COMPLIANCE SUBMISSION

PROJECT TITLE: **ST EDMUNDS - PHASE 3**
DRAWING TITLE: **BLOCKS 2 & 3 SECTIONS**

DATE: APR'22
SCALE: 1:200
JOB NO: 18025.2
DRAWING NO: CP204

SECTION B-B

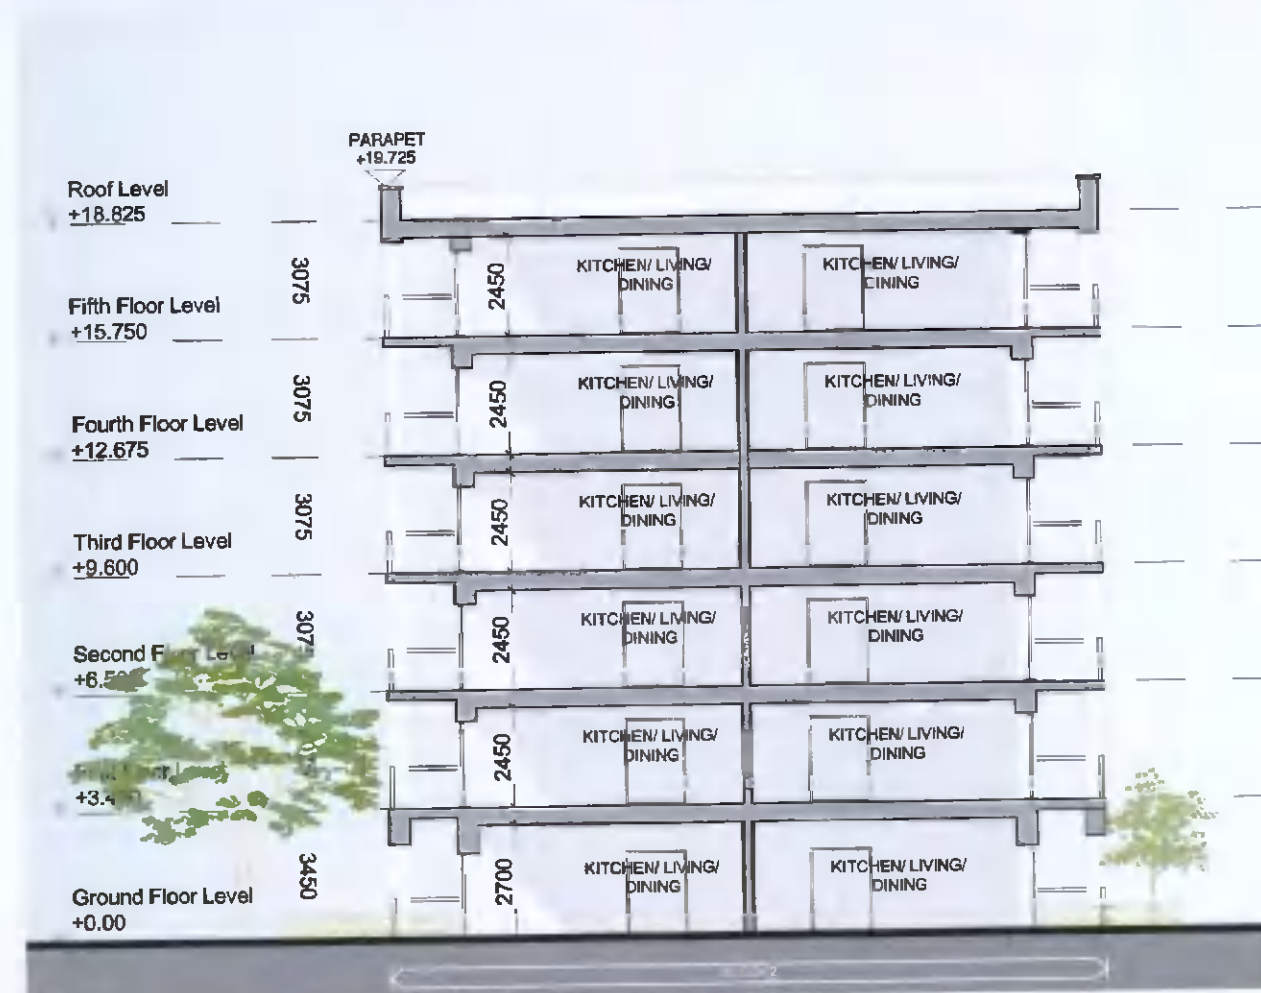
Render removed from material palette as per ABP conditions
